# ENGINE—CYLINDER HEAD DECK LEAK—4.6 AND 5.4L ENGINES—NEW “SERVICE-ONLY” GASKET AND CYLINDER HEAD KITS AVAILABILITY

Article No.  
03-6-2

Article **02-22-7** is being republished in its entirety to update the Model Year and Model Line coverage.

Figure 1 - Article 03-6-2

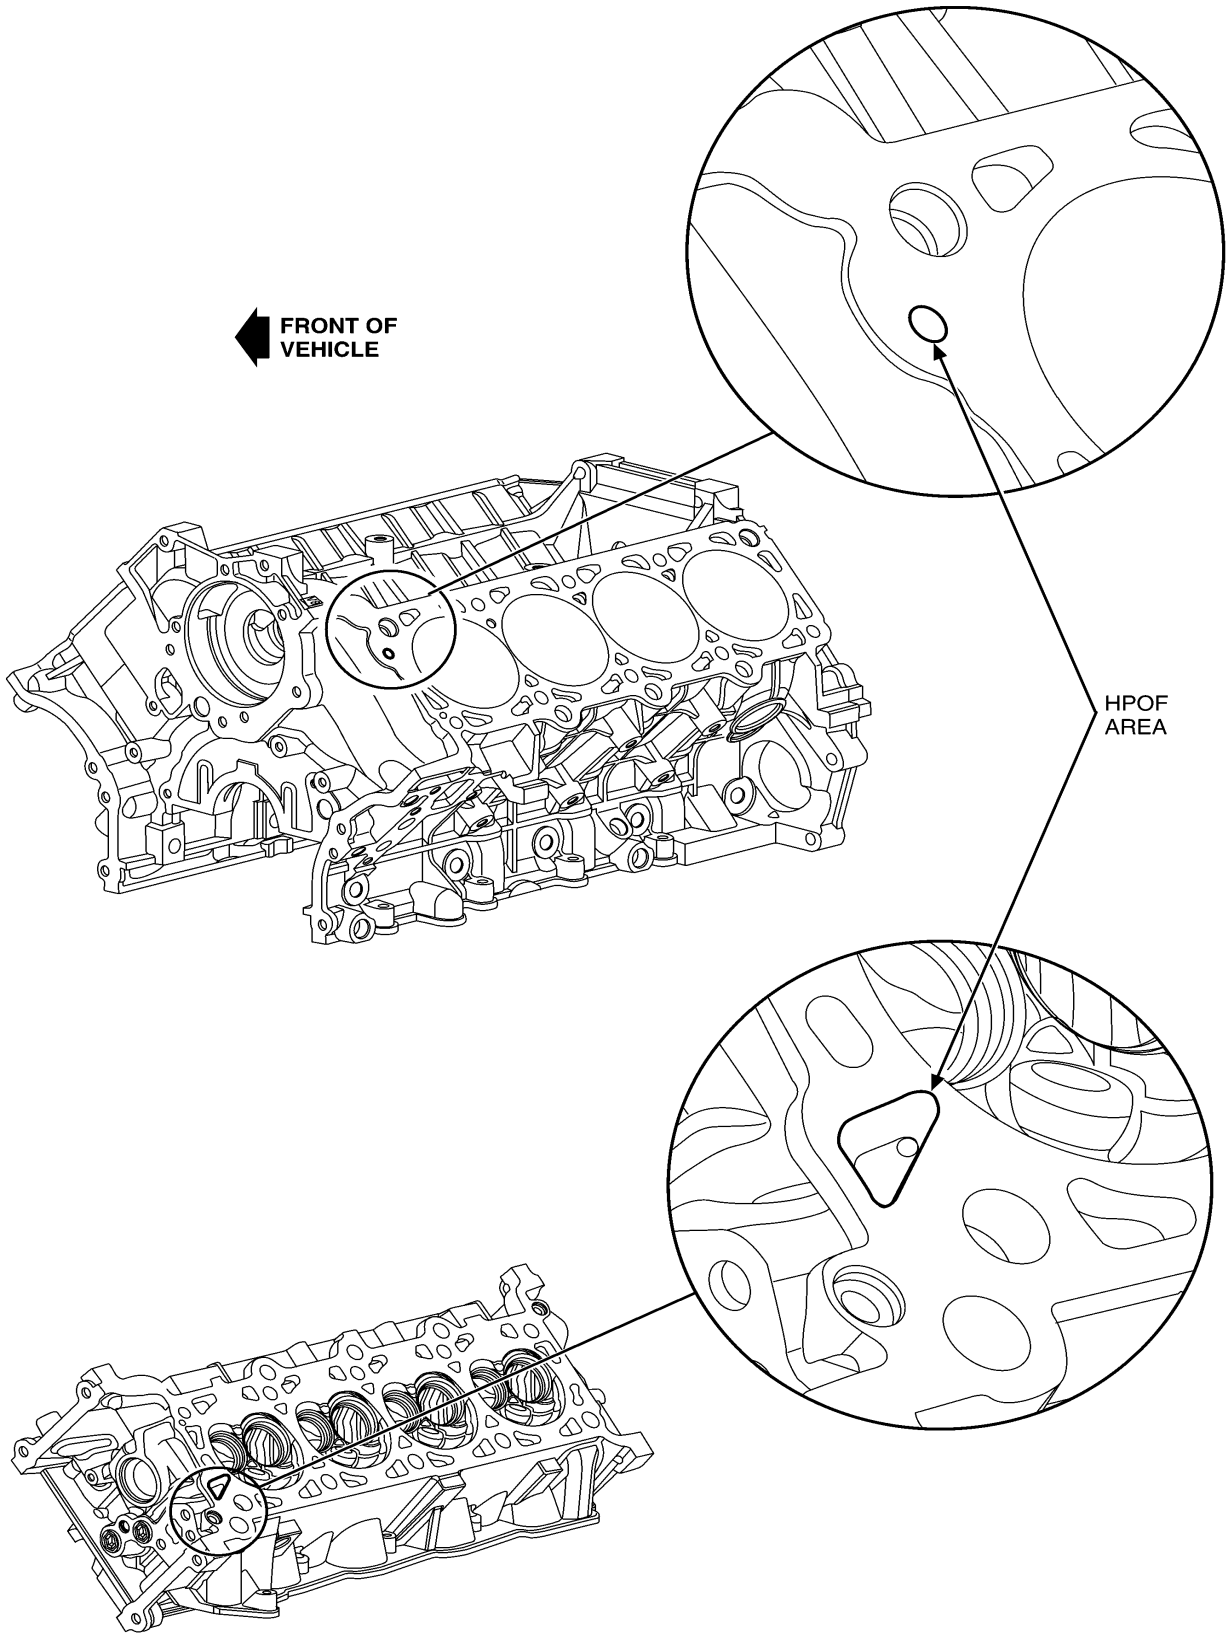
Cylinder heads damaged by brinnelling (depression marks from original gasket) of the head may still be reusable. The revised “Service-Only” gasket has a feature by which the embossed sealing area does not follow the same sealing path as the original gasket. This area is surrounding the High Pressure Oil Feed (HPOF) area. It is triangular in shape and is found in the rear of the passenger side cylinder head, or, in the front of the drivers side cylinder head (Figure 1 and Figure 2).

- A straightedge (machine flatness toleranced to 0.0002” per foot in length) (available from Snap-On or as provided by Ford Motor Company)
- Motorcraft Silicone Gasket Remover (ZC-30)
- Metal Surface Prep (ZC-31)
- Service-only gasket (3U7Z-6051-BA for drivers side and/or 3U7Z-6051-AA for passenger side) with the new embossed area
